UNITED STATES PATENT AND TRADEMARK OFFICE

APPLICATION NO.	FILING DATE	FIRST NAMED INVENTOR	ATTORNEY DOCKET NO.	CONFIRMATION NO.
10/731,705	12/09/2003	Timothy J. Wojcik	86236WRZ	5248

Office Action Summary

DETAILED ACTION

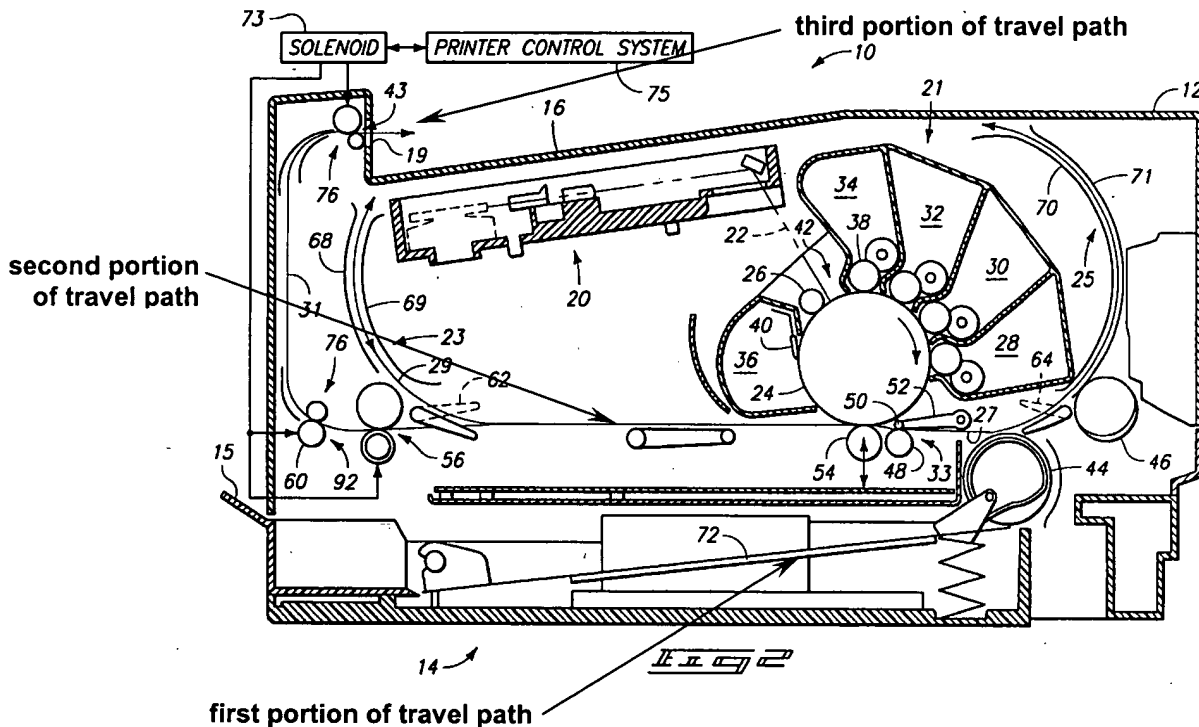
With respect to claim 7, Goldberg et al. discloses the claimed system for printing except for the second portion of travel. However, Guerrero et al. discloses a printing system that includes a first portion and an overlapping second portion of the travel path as shown below in the Figure taken from Figure 2 of Guerrero et al.:

With respect to claim 8, Guerrero et al. teaches a third portion as shown in the above Figure taken from Figure 2 of Guerrero et al. The third portion overlaps a portion of the second portion.

With respect to claim 9, Guerrero et al. teaches a first and second portion of the recording element travel path such that the directions of the travel paths are opposite of one another as shown above.

With respect to claim 10, Guerrero et al. teaches a third portion of the travel path having a third direction of travel that is substantially similar to the first direction of travel as shown above.
